ANN ARBOR HISTORIC DISTRICT COMMISSION

Staff Report

ADDRESS: 1201 Gardner Avenue, Application Number HDC24-0018

APPLICATION: The applicant seeks HDC approval to relocate a rear door opening, near the garage, into a new exterior wall with a new door.

PROPOSED FIRST FLOOR
SCALE: 1/8"=1'

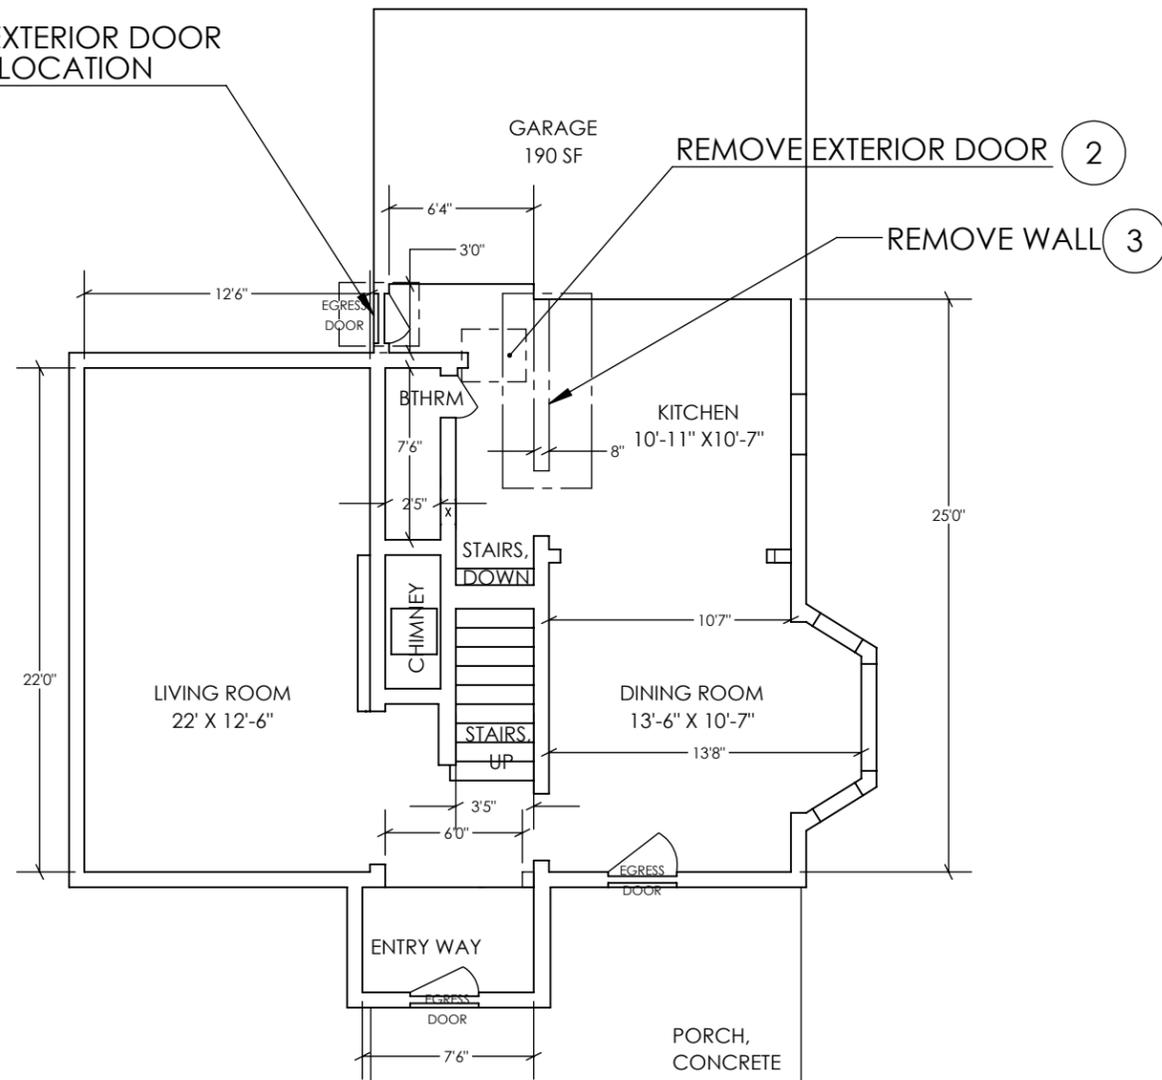
1. The house, including its attached garage and carport, is a contributing historic structure. The applicant proposes to move the back door on the north elevation of the house, currently in an alcove formed by the garage, to face east in order to capture significant interior space.
2. The age of the existing back door is not specified. The Study Committee Report indicates that it is wood. The proposed new door is wood with a simple vertical line detail. When asked why this door was chosen, the applicant explained that this design was important to the homeowner. Staff believes that the door is compatible enough, though a half-lite or

3. The rear entry is a character-defining feature of the house, though because it is recessed, it door is not very visible from the street (though the recessed entry is). Staff believes that moving the door is a reasonable request to make interior space significantly more efficient. The HDC will need to determine whether the work alters historic spaces and features in an acceptable manner.

**ELEVATION
PROPOSED
VIEW EAST
SCALE 1/8"=1'0 (1:96)**

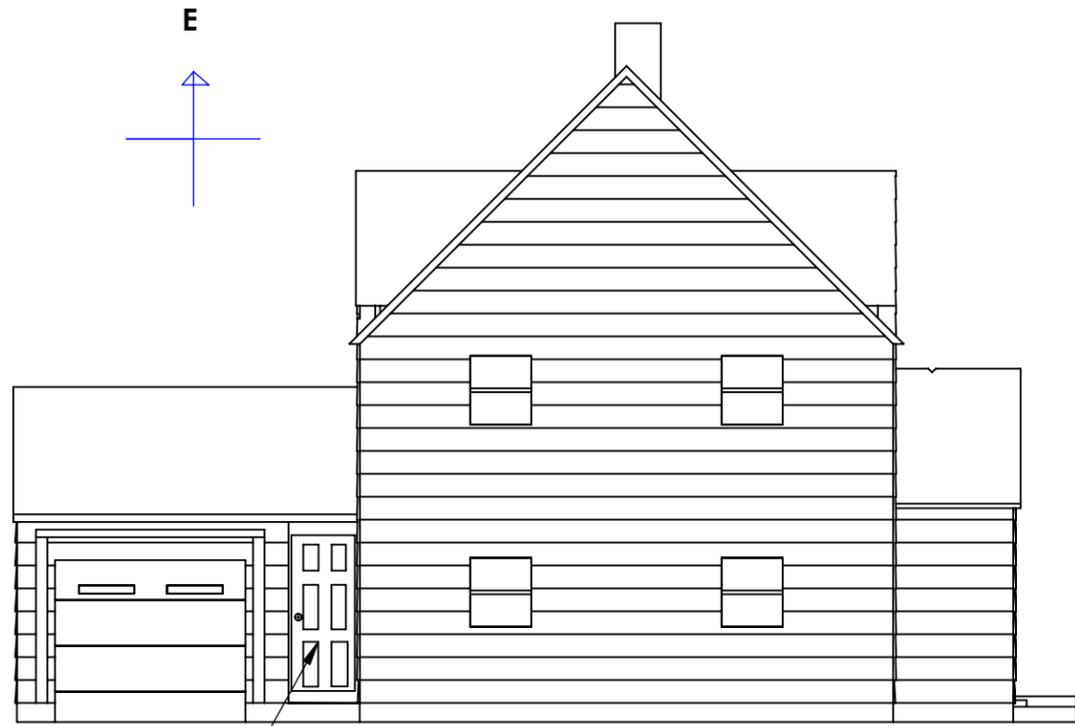
paneled door might be even better. Reusing the existing rear door could be an option, though a historic door in a non-historic location could confuse the historic record. Shakes from the back wall would be relocated onto the new wall surrounding the door. Staff believes this is acceptable for compatibility, though again, there is a question about whether it confuses the historic record.
